# LAND USE REVIEW RESPONSE

March 28, 2025 Second Response

PROJECT NAME	SITE ADDRESS	REF. NO.
1793 SILVERTON	1793 SILVERTON ROAD NE	24-124647-PLN

#### **523.010(d)(3) Development Site Landscaping –**

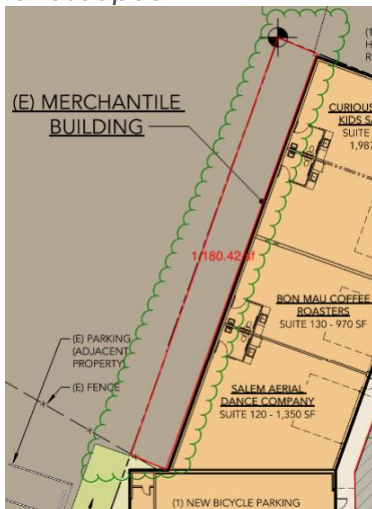
- *Per SRC 523.010(d)(3), the CG zone requires a minimum of 15 percent of the development site be landscaped to a Type A standard. Per Marion County Assessor records, the development site measures approximately 96,695 square feet in size across the three parcels. As such, a minimum of 14,504 square feet of the development site is required to be landscaped.*

*A Class 2 Adjustment may be supported if the overall site landscaping is brought closer to the 15% standard. Please note any landscaping within the special setback does not*

count towards the development site landscaping. Upon request, the Class 2 Adjustment fee will be added and will be required to be paid prior to deeming the application complete.

- **3/3/2025-** Fee has been added. The findings have been provided; however, the findings for development site landscaping adjustment do clearly demonstrate how the standard is equally or better met. The proposal findings cite that additional landscaping cannot be added to site without impacting another standard's conformance or reduce the number of parking spaces provided on site. Based on the plans, there appears to be a portion of the site along the northwestern section that can be landscaped and measures roughly 1,180 square feet. Please clarify the use of this area and how this area cannot be landscaped

**RESPONSE:** The applicant and their consultants believe the project is limited to a single taxlot (073W14AD04500) which, according to the Marion County Assessor's Record, is 26, 281 square feet or 0.6 acres. This brings the 15% landscape requirement to 3,942.15 square feet. While the total amount of landscaping is less than you noted, a Class 2 adjustment is still necessary as site constraints and existing development conditions make it impractical to increase landscaping beyond what has recently been installed on this property. Please see the updated narrative provided with the resubmittal materials for the formal request. The applicant is aware that fees associated with additional land use reviews will be assessed to this project and that those fees must be paid as part of the Completeness Review.

**RESPONSE:** The applicant will pay the remaining land use application fees as needed. Please see the response to the secondary comment related to landscaping of *Perimeter Setbacks and Interior Landscaping*. The owner will add perimeter landscaping adjacent to the western property line and also will add interior landscape planters within the parking area to increase overall landscaping and to provide some form of interior landscaping.

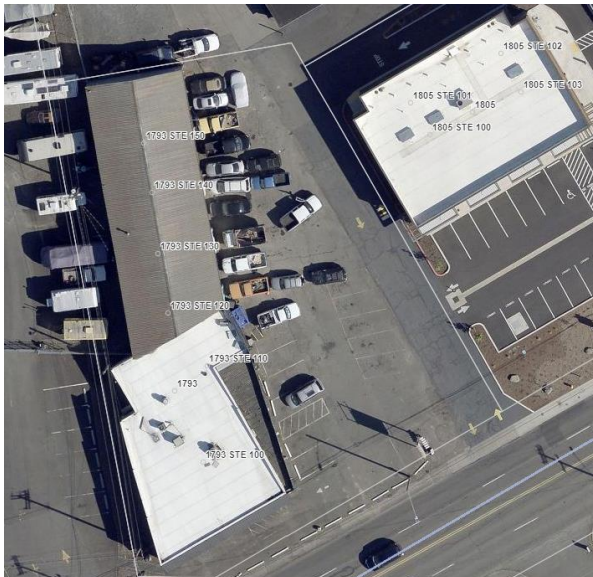
- **Vehicle Use Areas – Perimeter Setbacks & Adjustments –**  
Based on aerials of the site, the off-street parking area was recently resurfaced and reconfigured without permits or prior Site Plan Review. As such, current standards of 806 apply to the parking area. The applicant's written statement identifies three adjustments to the following standards:
  - SRC 806.035(c)(2) – Perimeter Setbacks and Landscaping Abutting Streets

- SRC 806.035(c)(3) – Perimeter Setbacks and Landscaping Abutting Interior Side and Rear Property Lines
- SRC 806.035(d)(2) – Minimum Percentage of Interior Landscaping Required

The findings for the perimeter setbacks and landscaping identify that the standard is not applicable as justification for adjustment. The standard is applicable, and applicant shall demonstrate how intent of the standard is equally or better met through a revised written statement and any supportive materials necessary to demonstrate that the criteria is met. Staff could potentially be supportive of the adjustments if the intent of the setback which is to provide separation between vehicle use areas and break up the mass of paved surfaces with landscaping can be demonstrated through the existing and/or proposed landscaping on the site. Please note that the perimeter setbacks are not required along the flag lot accessway or driveways.

The adjustment sought for the 5% minimum required landscaping is not equally or better met by the proposed development. The parking area was resurfaced and reconfigured without prior approval so the standard is triggered and required to be met or the adjustment criteria to be clearly met by proposing landscaping that equally.

**RESPONSE:** The property owner made repairs that included grinding and inlaying asphalt over the existing surface; however, the asphalt was not removed and replaced, and no grading was done. The amount of existing asphalt was reduced to create a landscape strip between the street property line and the building. Increasing the size of the new landscape strip or adding landscape beds within the parking area would negatively impact the development by reducing the available parking (currently limited to 20 spaces), which is well below the maximum allowed (41 spaces), and impacting vehicle maneuvering areas. The requested Class 2 adjustments for perimeter and interior landscaping are still necessary. The narrative has been revised to include the required argument. Additionally, it is the applicants understanding that the City of Salem does not prefer for the site to be brought back to those previous conditions (see below 2021 aerial) as the degree of non-conformance would be greater than that of the current conditions.

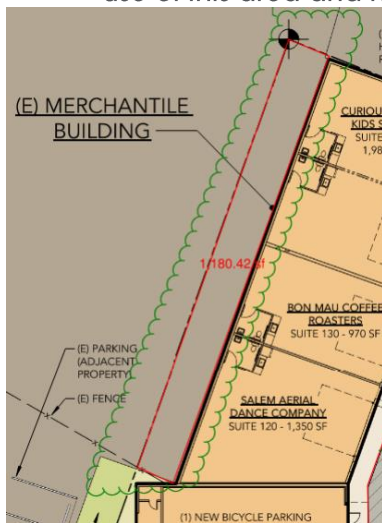
- **3/3/2025-** The findings have been updated; however, the findings for interior parking adjustment do clearly demonstrate how the standard is equally or better met. The proposal findings cite that additional landscaping cannot be added to site without impacting another standard's conformance or reduce the number of parking spaces

provided on site. Based on the revised plans, there appears to be additional area dedicated to the turnaround area not required by code and other surfaced areas within the surfaced parking area not used for parking spaces or within an area where a setback is sought to be eliminated. As currently proposed, it is unclear how the criteria is met while there are areas that appear to be able to be landscaped without impacting the number of off-street parking spaces and overall configuration of the parking area. There appears to be a portion of the site along the northwestern section that can be landscaped and measures roughly 1,180 square feet. Please clarify the use of this area and how this area cannot be landscaped.

**RESPONSE:** Additional landscaping, along the western edge of the subject property and within the off-street parking areas is proposed. This will bring the total amount of landscaping on-site up to 3,184 square feet. The “interior landscaping” which currently does not exist, will add approximately 369 square feet, which does show an effort to reduce the amount of non-conformance within the existing off-street parking area. While the added landscape will add landscaping, it still falls below the minimum amounts the Code is seeking so the requested adjustments related to overall landscaping and interior landscaping still apply.

It is important to note that the northern interior landscape bed will not be irrigated through an inground irrigation system, the property owner will instead hand water this bed to ensure the plantings are maintained as required.

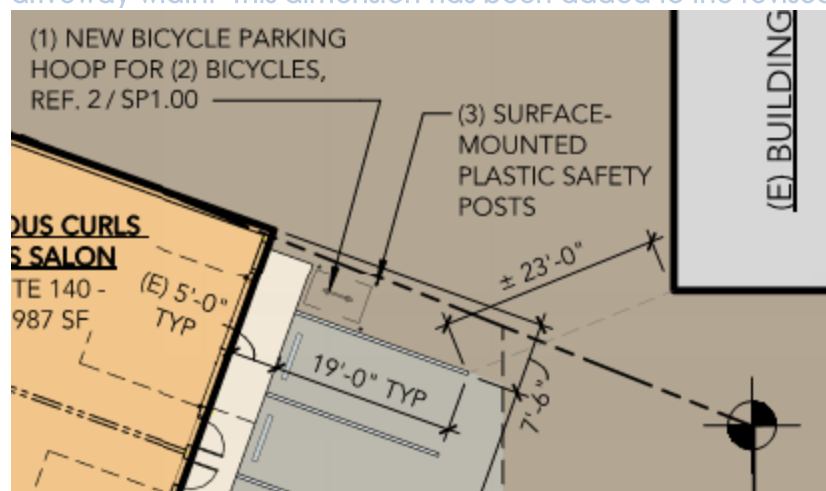
SRC 806.040(d) requires a minimum width of 22 feet for two-way driveways. The proposed parking space narrows the width of driveway used to access northern property to less than 2 feet. Please revise the plans to allow a 22-foot-wide driveway to allow access to northern property.

**RESPONSE:** The width of the maneuvering area in this location 23-feet meeting the standard for

driveway width. This dimension has been added to the revised Site Plan as well.
